**Planning Department
Transportation Development Services**

**Re: A Façade Renovation
111 Cardenas NE
Traffic Circulation Layout**
Engineer's/Architect's Stamp dated 10-9-15 (K18-D106)

Based upon the information provided in your submittal received 10-9-15, the above referenced plan cannot be approved for Building Permit until the following comments are addressed:

TRAFFIC CIRCULATION PLAN 111 CARDENAS DR NE
1/16" = 1'-0"

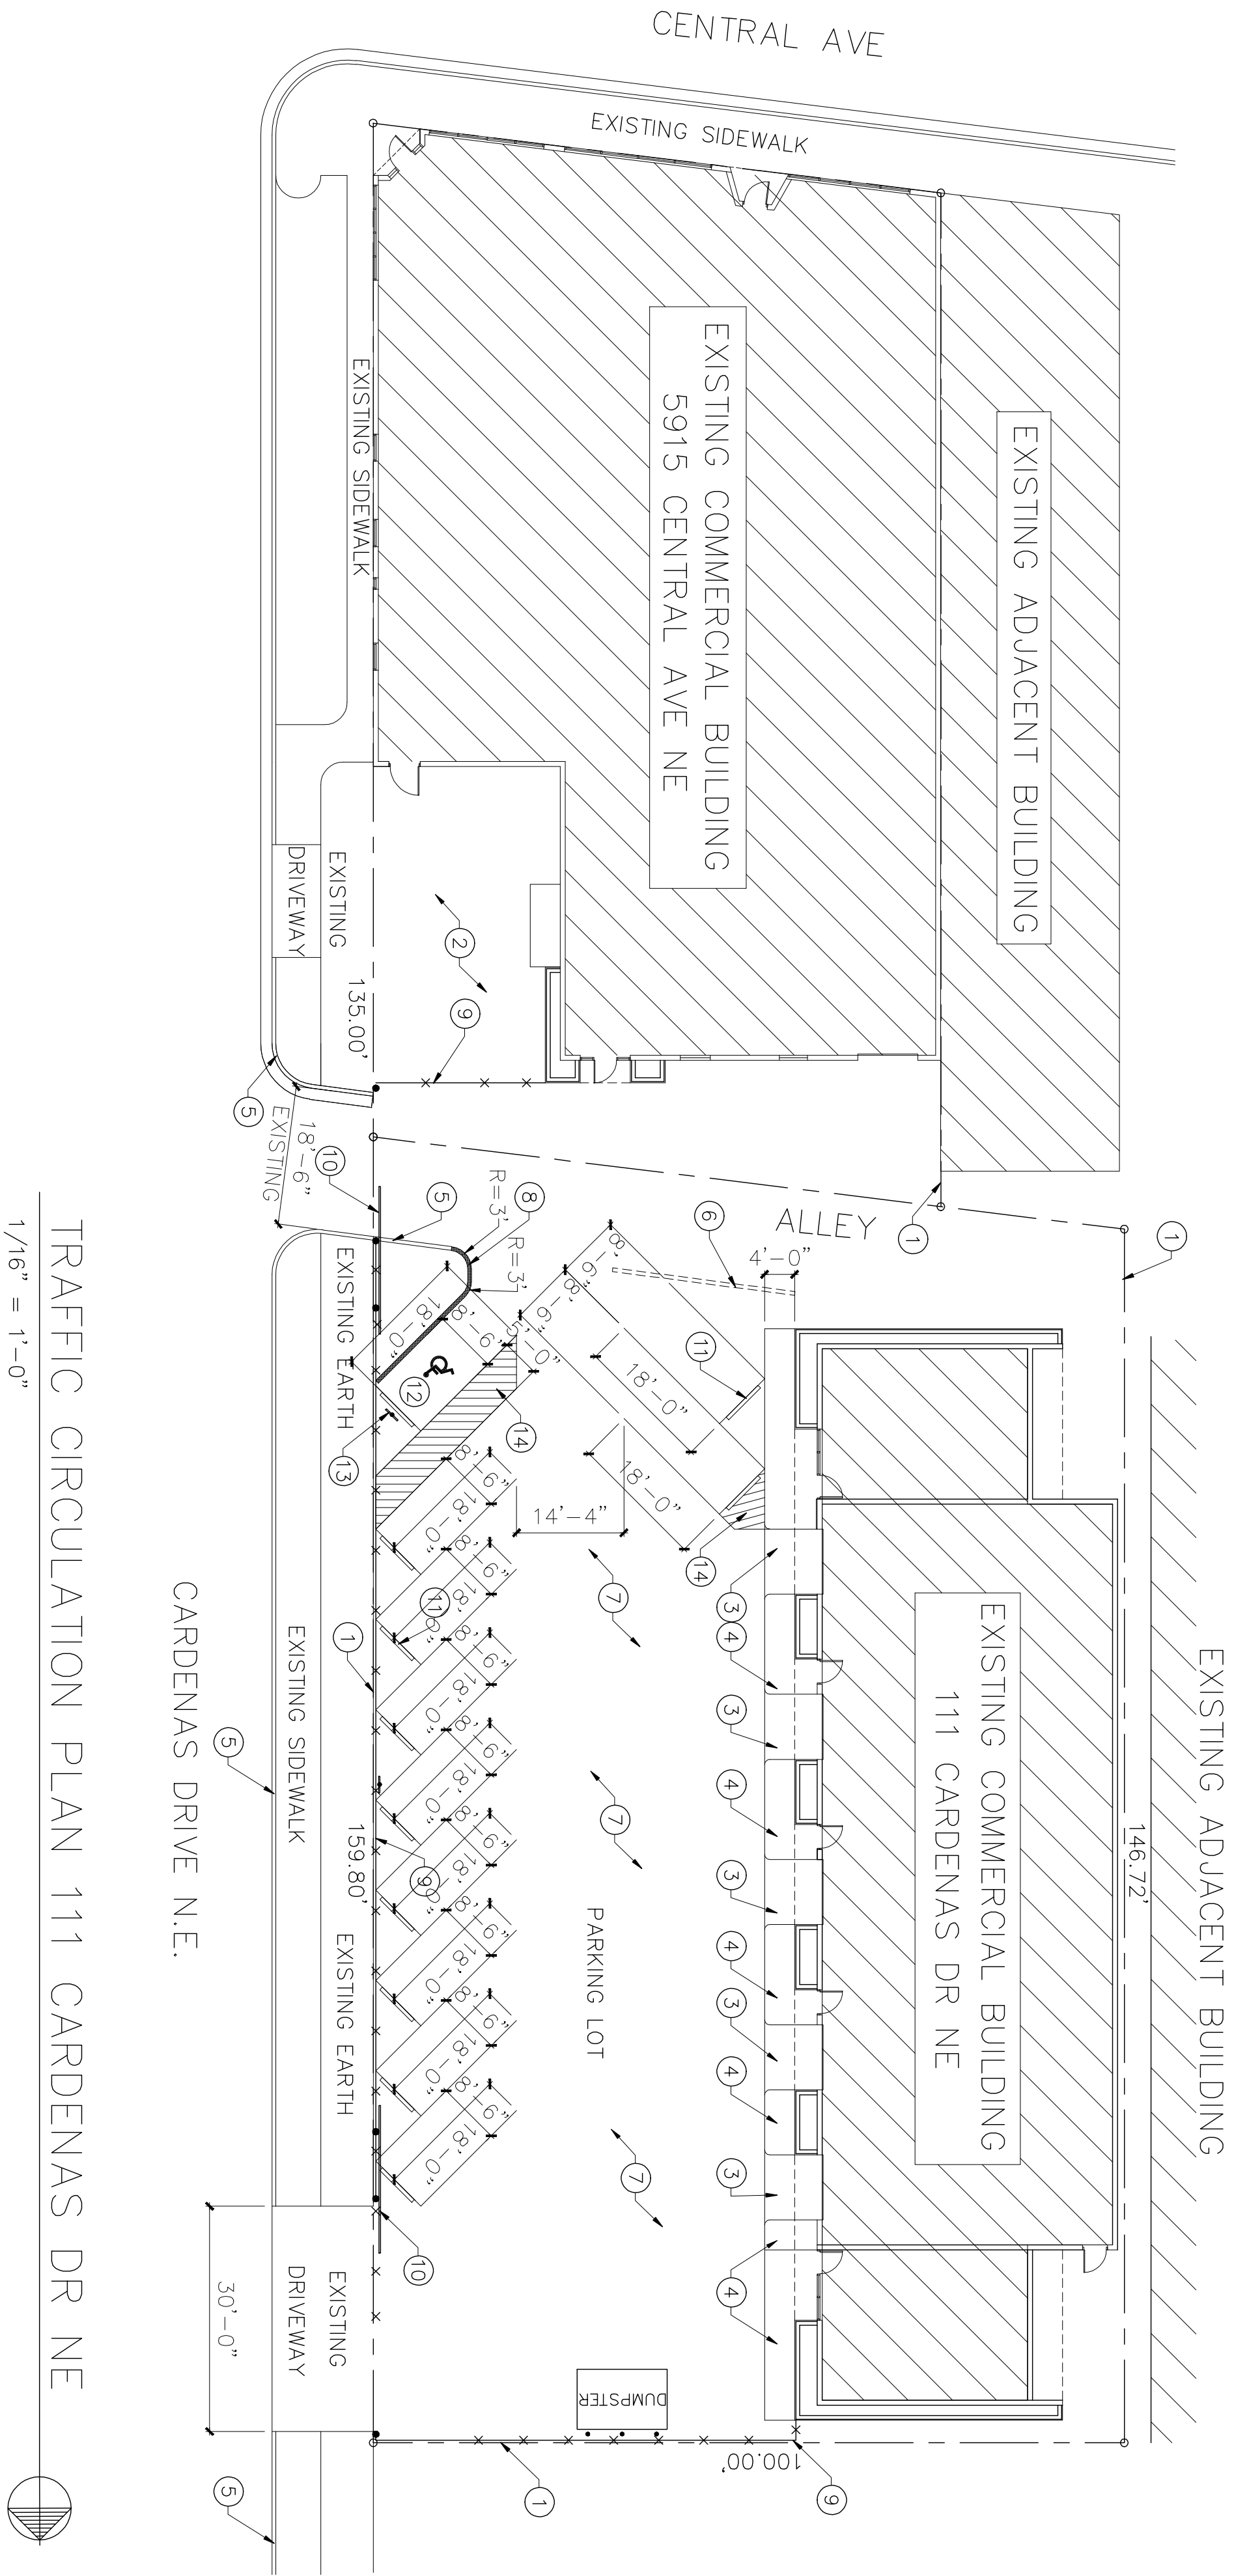
1. Please show a vicinity map showing the location of the development in relation to streets and well known landmarks.
2. List the number of parking spaces required by the zoning code, as well as the proposed number of parking spaces.

3. Clarify the extents of the current phase.
4. Please identify all existing electrical and light poles that influence the parking and circulation on the site.

5. Identify all existing access easements and rights of way with dimensions.
6. Identify the right of way width, medians, curb cuts, and street widths on Cardenas Dr.

7. Please list the width and length for all parking spaces. Identify the distance between all angled parking spaces. Per DPM, there must be an 11 ft. drive isle between angled parking spaces.

8. The ADA accessible parking sign must have the required language per 66-7-352.4C NMSA 1978 **"Violators Are Subject to a Fine and/or Towing."** Please show a detail of this signage.

9. The ADA access aisle shall have the words **"NO PARKING"** in capital letters, each of which shall be at least one foot high and at least two inches wide, placed at the rear of the parking space so as to be close to where an adjacent vehicle's rear tire would be placed. (66-1-4.1.B NMSA 1978)

10. Show all drive aisle widths and radii.

11. List radii for all curves shown; for passenger vehicles, the minimum end island radius is 15 feet. Landscape island radius for delivery trucks, fire trucks, etc. is 25 feet or larger

12. Per the DPM, a 6 ft. wide ADA accessible pedestrian pathway is required from the public sidewalk to the building entrances. Please clearly show this pathway and provide details.

13. Per the DPM, a 6 ft. wide ADA accessible pedestrian pathway is required from the HC parking stall access aisles to the building entrances. Please clearly show this pathway and provide details.

14. Provide a min 6" or max 8" high concrete barrier curb or other acceptable barrier between landscaping and parking areas and/or drive aisles.
15. Design delivery vehicle route needs to be shown.

16. Service vehicle and/or refuse vehicle maneuvering must be contained on-site; provide a copy of refuse approval.
17. It is not apparent what type of pavement surface is being proposed. A hard driving surface will be required as part of this proposed project for parking area and drive aisles. The drawing states that there is "existing earth", please clarify detail.

18. Please clarify how the site meets clear sight triangle requirements.
19. Please provide a sight distance exhibit (see the *Development Process Manual, Chapter 23, Section 3, Part D.5 Intersection Sight Distance*). Please provide this detail on Cardenas Dr.

20. Please add the following note to the clear sight triangle: "Landscaping and signage will not interfere with clear sight requirements. Therefore, signs, walls, trees, and shrubbery between 3 and 8 feet tall (as measured from the gutter pan) will not be acceptable in this area."
21. Please include a copy of your shared access agreement with the adjacent property owner.

22. Unused curb cuts must be replaced with sidewalk and curb & gutter. A build note must be provided referring to the appropriate City Standard drawing.
23. Please include two copies of the traffic circulation layout at the next submittal.
